**SBLOCA TeR Questions for KHNP for the Wednesday, November 18, 2015 Telecom**

**(1) APR1400 Loop Seal Clearing**

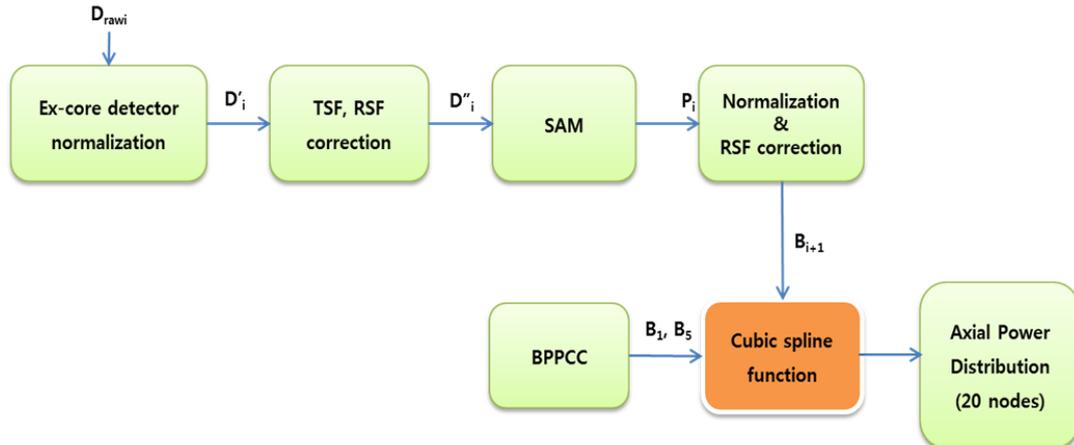
- b. The present reviewers have questions regarding the sensitivity of the method to fuel burnup, CEA position, and cycle to cycle variation in loading pattern

Nuclear design group generates the nuclear design data based on the fuel burnup, CEA position and loading pattern for every reload cycle. COLSS/CPCS design group generates 1200 cases axial power shapes using these nuclear design data. Then, these power shapes will be used to generate the uncertainty factors for DNBR and LPD calculation through CPCS Overall Uncertainty Analysis (OUA). CPCS OUA is performed at four burnup point; BOC, IOC, MOC and EOC. Among the four CPCS OUA results, the biggest DNBR and LPD penalties are determined and used in CPCS.
